NEW MEXICO OIL CONSERVATION DIVISION
- Engineering Bureau -
1220 South St. Francis Drive, Santa Fe, NM 87505

ADMINISTRATIVE APPLICATION CHECKLIST

Re: Application of Encana Oil & Gas (USA) Inc. for administrative approval of unorthodox well locations in the Counselor Gallup-Dakota Oil Pool (13379) for its Lybrook M27-2306 02H and Lybrook M27-2306 04H wells in Section 28, Township 23 North, Range 6 West, N.M.P.M., Sandoval County, New Mexico.

From: Brooks, David K., EMNRD
Sent: Tuesday, November 19, 2013 3:46 PM
To: mfeldewert@hollandhart.com
Subject: Encana - Lybrook M27-2306 ##2H & 4H; NSL Applications

WELL LOCATION AND ACREAGE DEDICATION PLAT

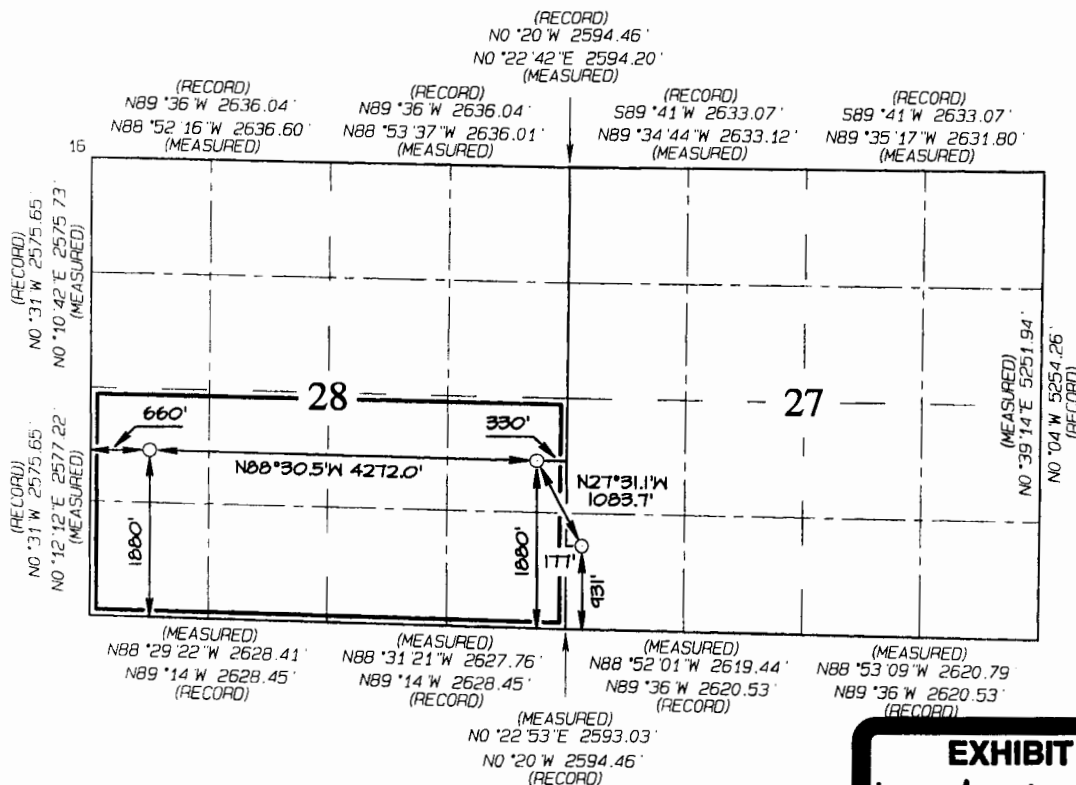
For the No. 2H, OCD records show SL at 960 FS & 181 FW and BHL at 1880 FS & 330 FW, whereas application shows SL at 931 FS & 177 FW and BHL at 1880 FS & 660 FW.

For the No. 2H, OCD records show SL at 960 FS & 181 FW and BHL at 1880 FS & 330 FW, whereas application shows SL at 931 FS & 177 FW and BHL at 1880 FS & 660 FW.

We have checked with Encana and confirmed that the C-102's submitted with the NSL application for the Lybrook N27-2306 02H and 04H wells correctly reflect how the wells will be drilled. There will be no encroachment to the West as reflected in the current C-102s on file with the BLM and the Division. Amended reports conforming to the NSL application will be filed with the BLM and the Division once the NSLs are approved.

Exhibit B

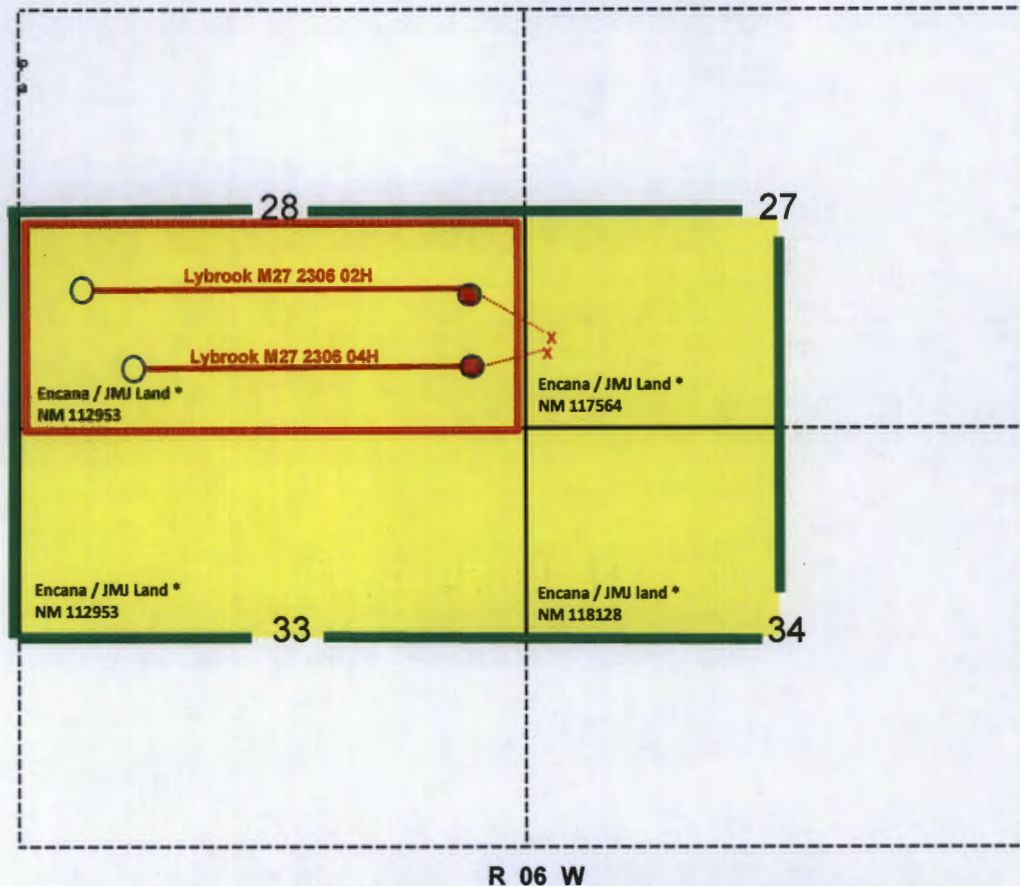
For the No. 4H, OCD records show BHL at 550 FS & 330 FW, whereas application shows BHL at 550 FS & 760 FW.

For the No. 4H, OCD records show BHL at 550 FS & 330 FW, whereas application shows BHL at 550 FS & 760 FW.
